## Product Change Notification / SYST-20UWAM093

ERRATA - dsPIC33CK256MP508 Family Silicon Errata and Data Sheet Clarification Errata Document Revision

## dsPIC33CK256MP508 Family Silicon Errata and Data Sheet Clarification

FIGURE 1-1: I/O RAMP

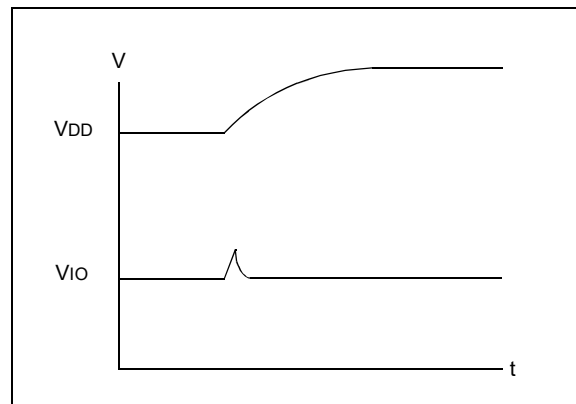
During a fast device power-up when the  $V_{DD}$  ramp is less than 4 mS, the I/O pins may drive up to 100  $\mu$ A current for a duration of up to 10  $\mu$ S (Figure 1-1).

1. Slow down the  $V_{DD}$  ramp time (greater than 4 mS for  $V_{DD}$  to ramp 0V to 3.3V).
2. Ensure the circuitry that is connected to the pins can endure this pulse.

Example applications affected may include complementary power switches, where a transient current shoot-through might occur. High-voltage applications with complementary switches should power the high-voltage 200  $\mu$ Sec later than powering the dsPIC<sup>®</sup> device to avoid the current shoot-through. This behavior is specific to each device and not affected by aging.
